SE159:Class II Permissive Change Application

Model : SE159

FCC ID: OW7-SE159

Version : 1.0

2.1 After modifications

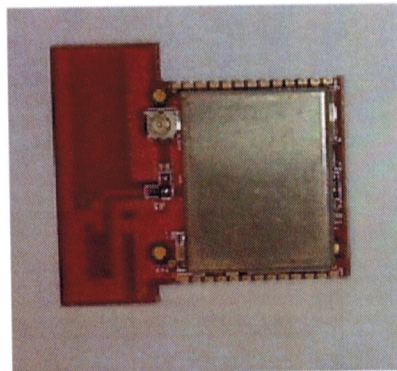
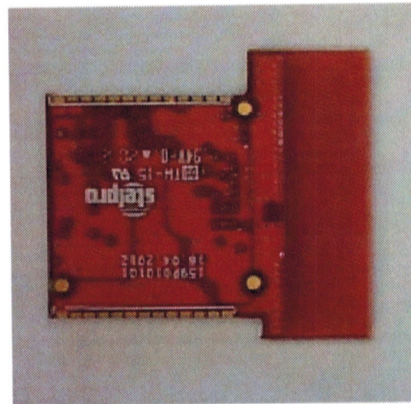
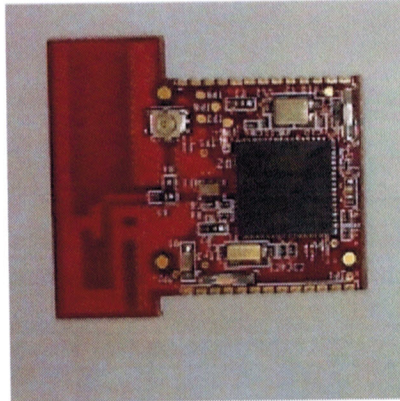
- We've changed the width of the antenna, it result in a decrease of the PCB width at the PCB antenna location
- We added a PI termination network for the PCB antenna.
